LAND  
DEVELOPMENT CODE  
ADVISORY GROUP

FINAL REPORT

JULY 6, 2017

**SUBJECT:** CodeNEXT Advisory Group (CAG) Report

Proposed Green Infrastructure/Landscape Buffer

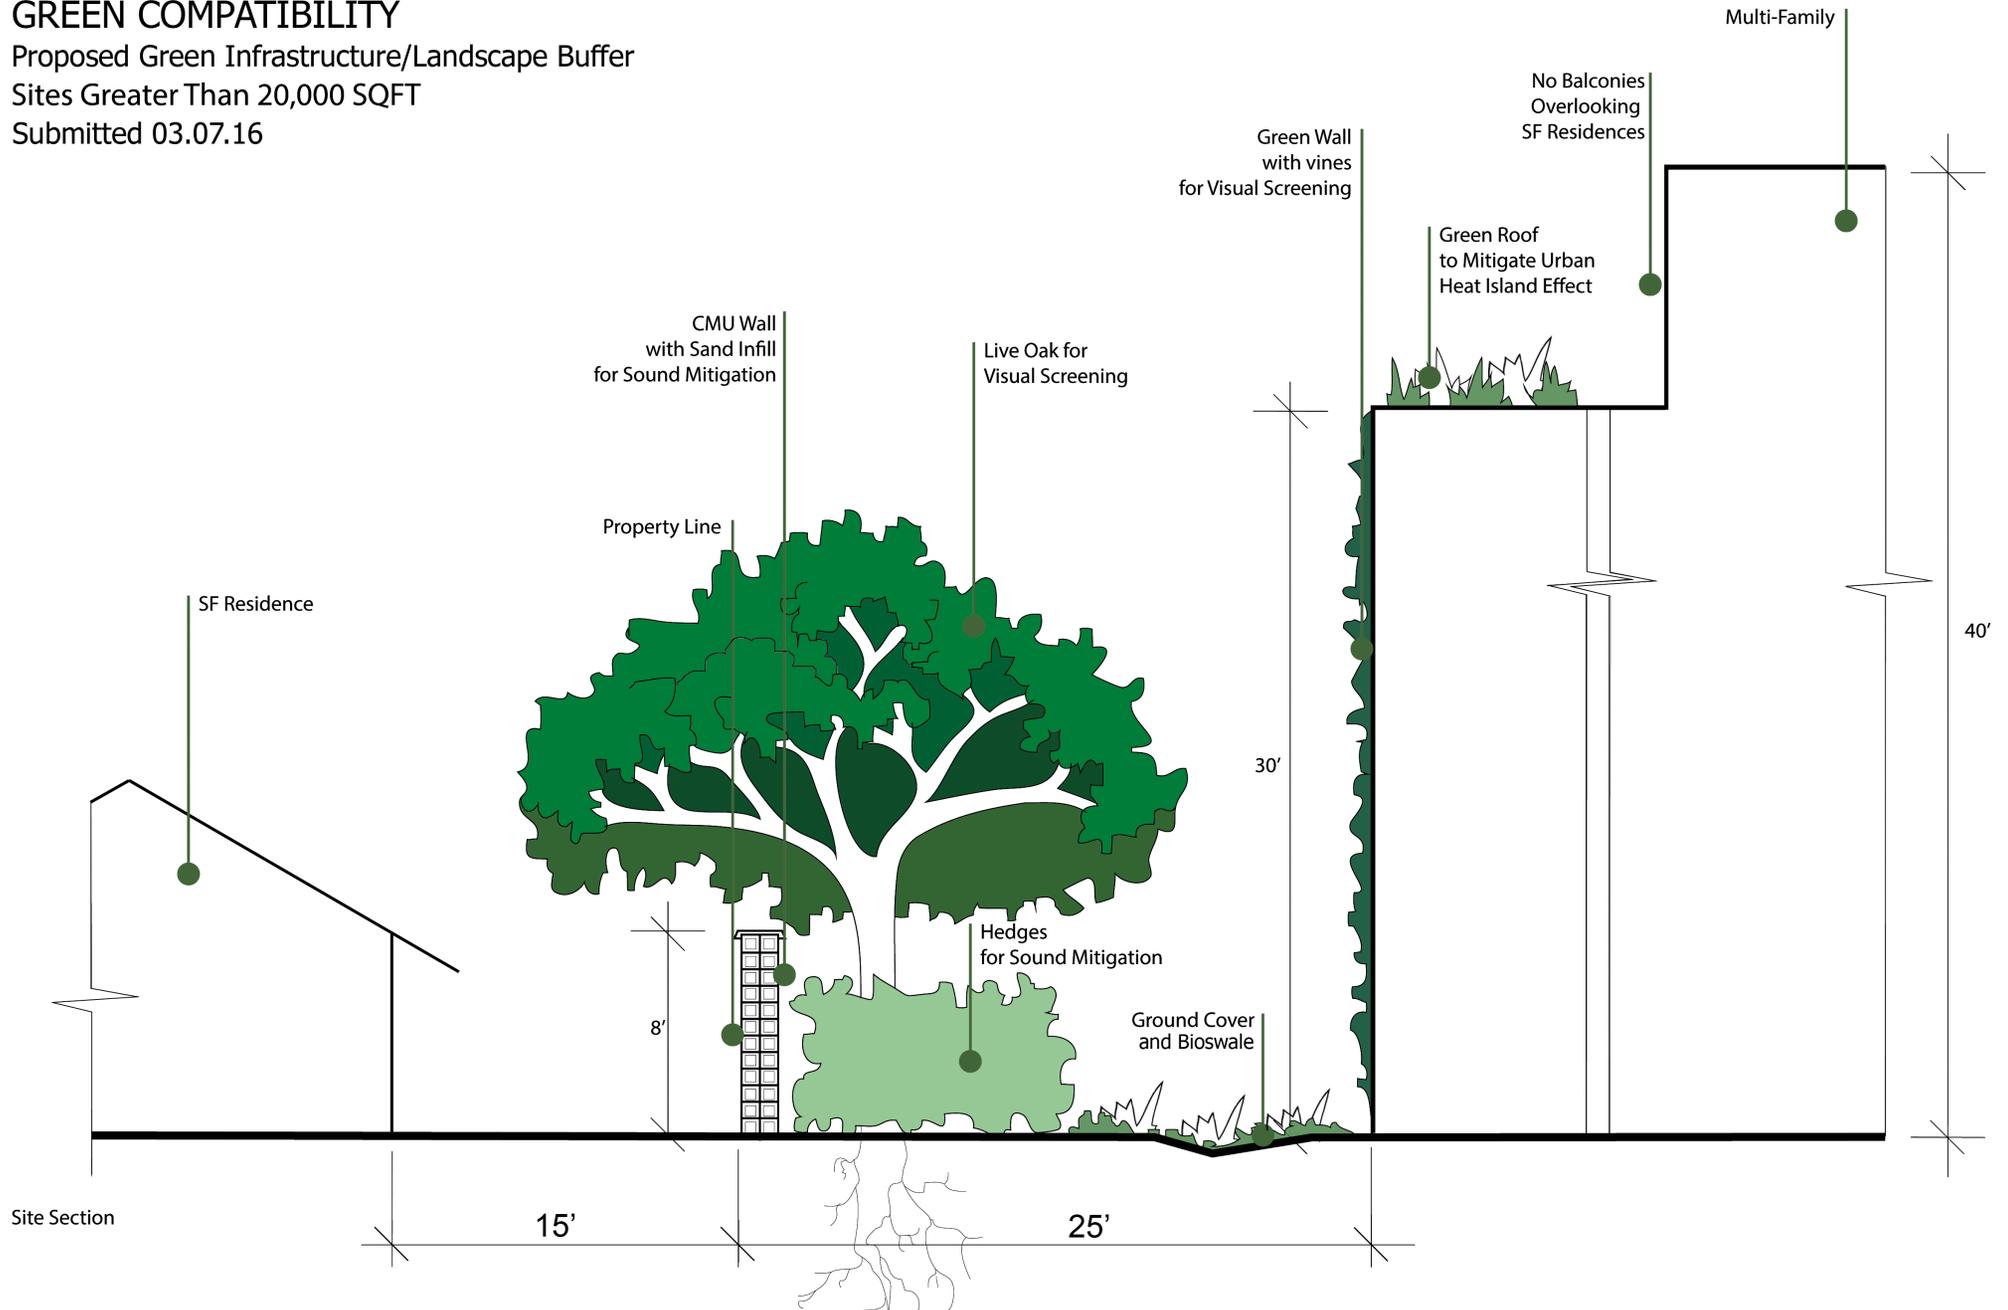
Sites Greater Than 20,000 SQFT
